**PLANNING AND ZONING COMMISSION
CITY OF BETTENDORF
AUGUST 19, 2020 AT 5:30 PM
CITY HALL COUNCIL CHAMBERS
1609 STATE STREET**

Staff Report

Case No. 20-045 (Rezoning) and Case 20-047 (Final Plat)

Case 20-046 (Replat) and Case 20-050 (Site Development Plan)

FINAL PLAT
THE WOODLANDS 4TH ADDITION
BETTENDORF, IOWA

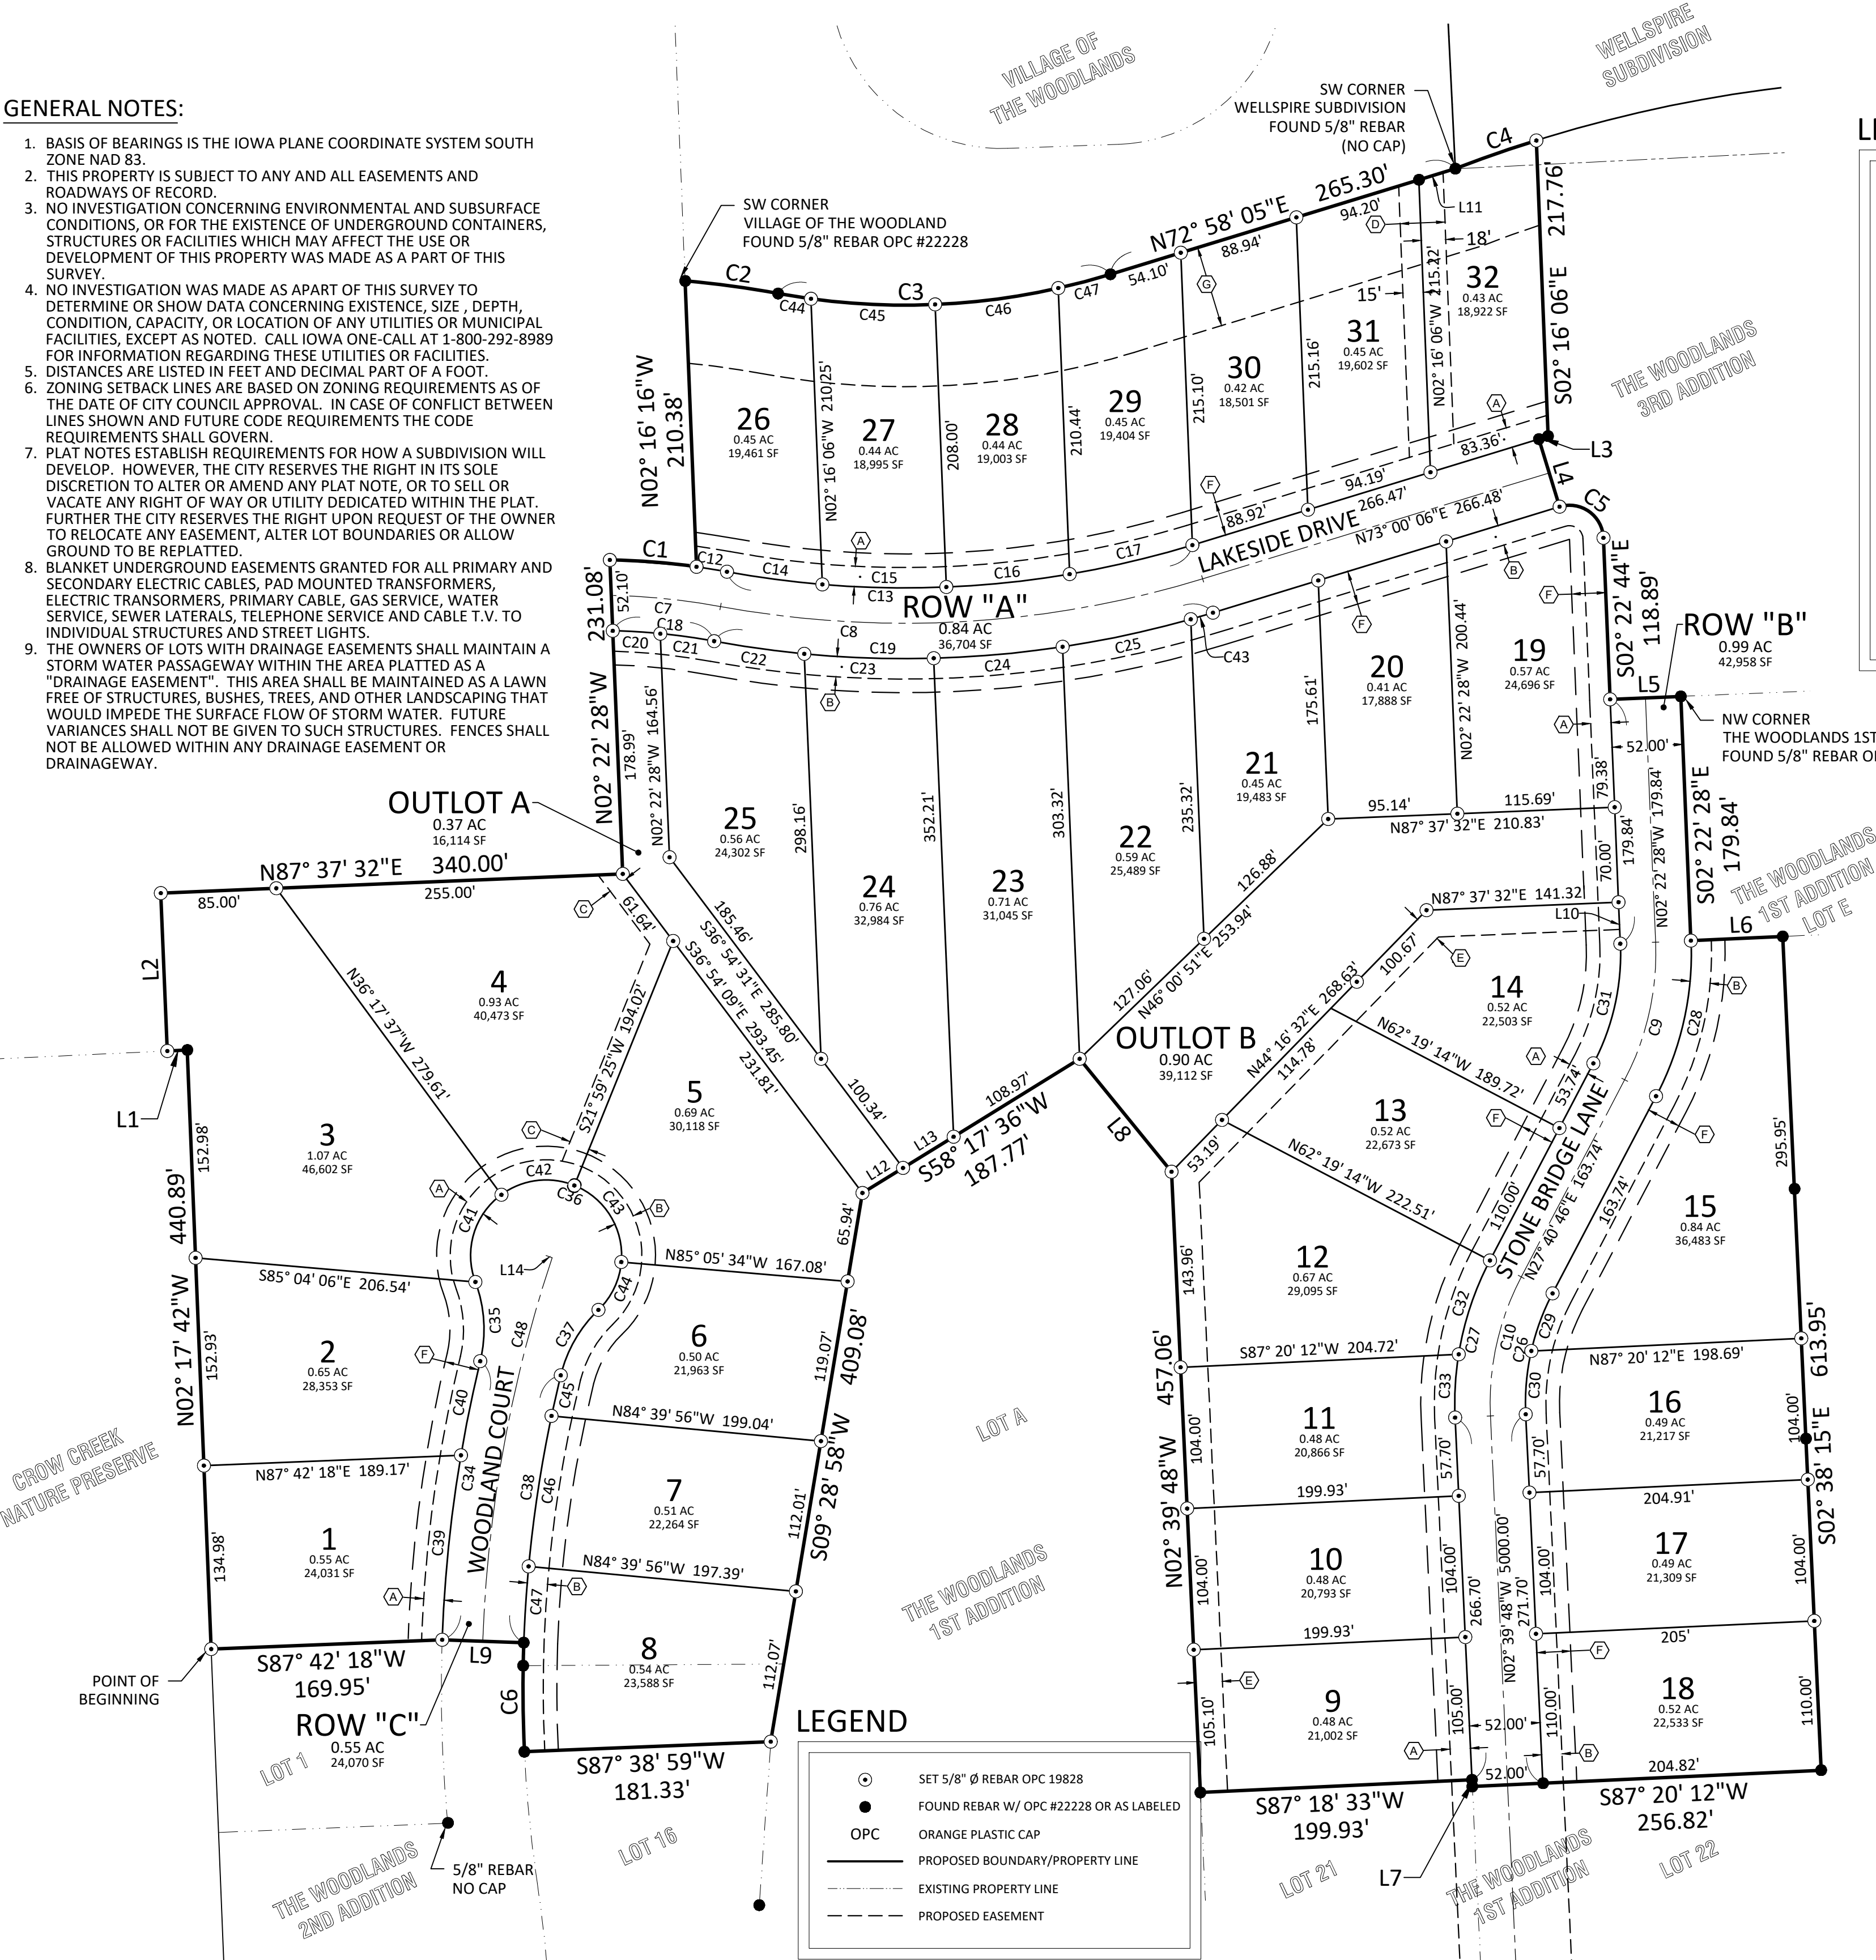
1. Approval of the rezoning request and the final plat does not waive any applicable city, state, or federal provisions as required by law.
2. A plat note regarding outlot care and responsibility must be placed on the plat.
3. Label the type of pin in the northwest corner of Lot 13.
4. Final plat approval will be concurrent with third and final reading of the rezoning ordinance.

TANGLEFOOT CROSSING ADDITION

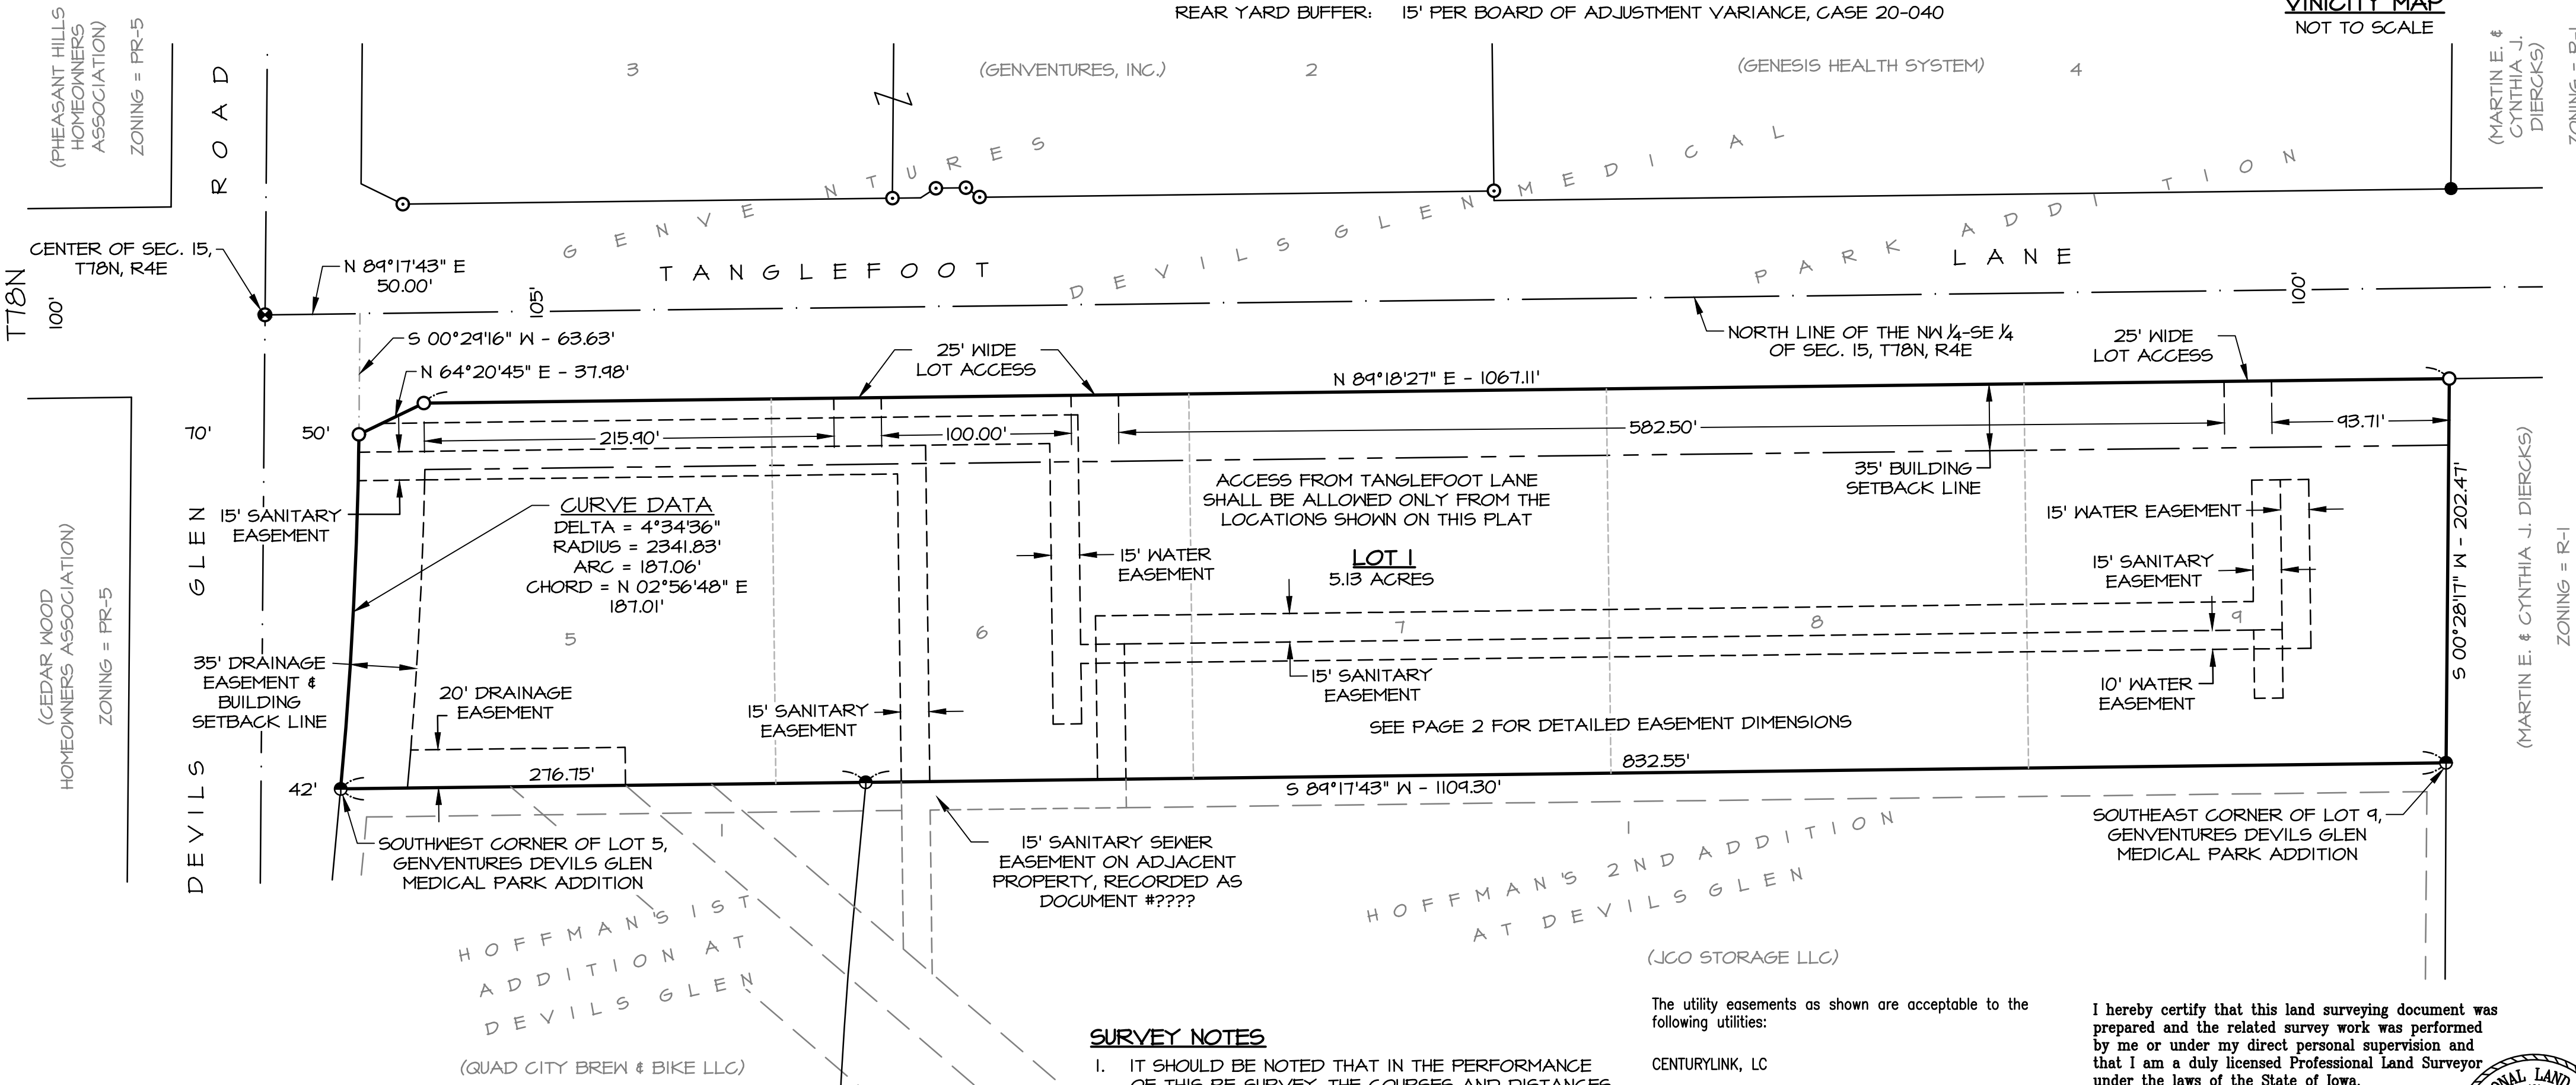
3. The City Engineer will verify that all utilities being rerouted through the former Lot 5, Genventures Devils Glen Medical Park Addition meet City standards.

4. Sewer easement for use of areas south of proposed subdivision to be recorded prior to City Council consideration of the final plat or site development plan.

5. The allowable number of units for the multi-family housing structure proposed to be located within the western portion of the subdivision will be based on the square footage indicated on a future site development plan for that purpose.

SITE DEVELOPMENT PLAN

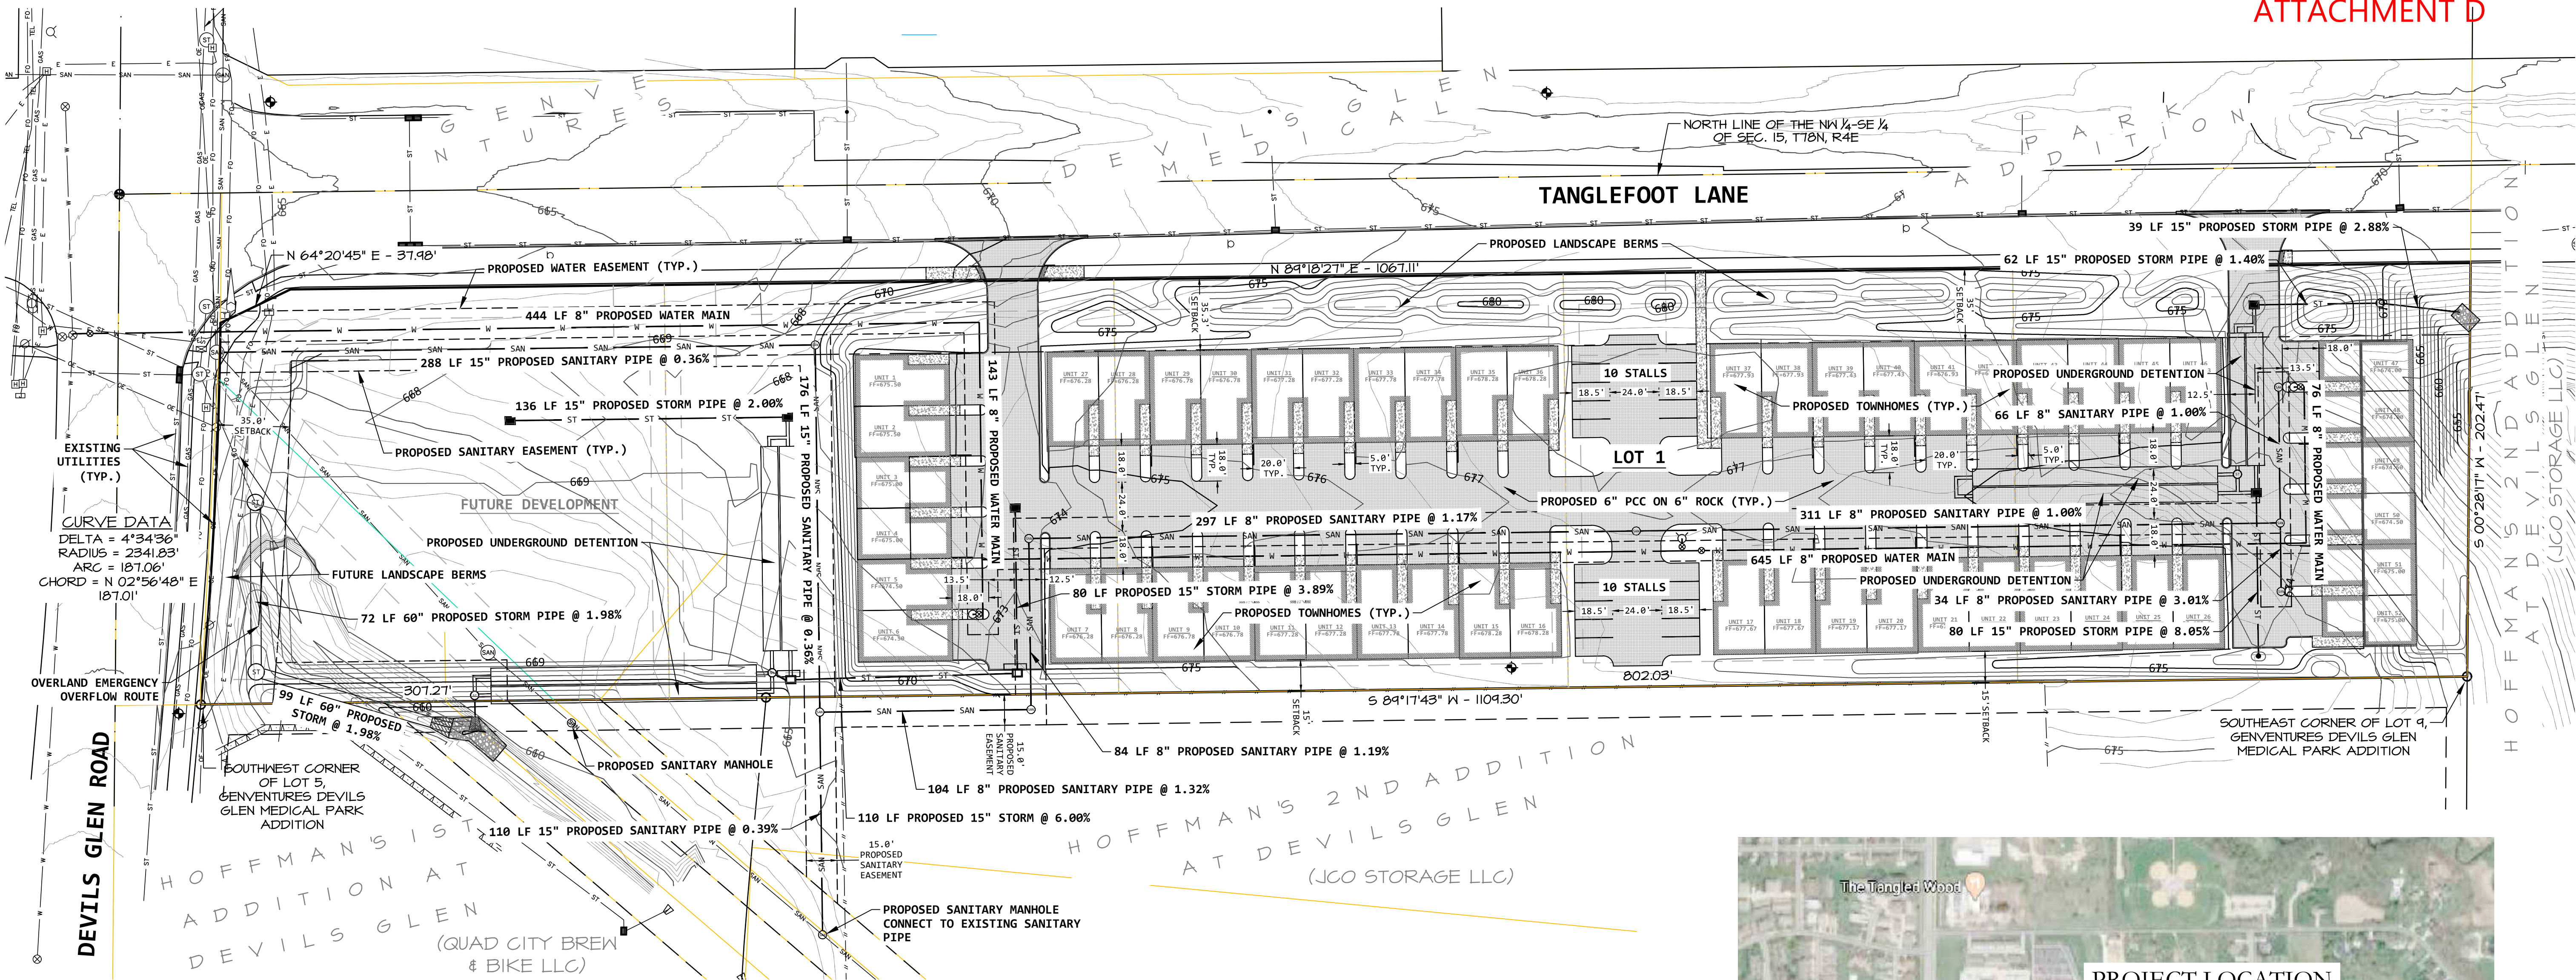
6. Tree count for streetscape requires 40 trees; only 23.5 tree credits are shown.
7. All Fire Department requirements for internal turning radii and drive widths shall be met prior to City Council consideration of this site development plan.
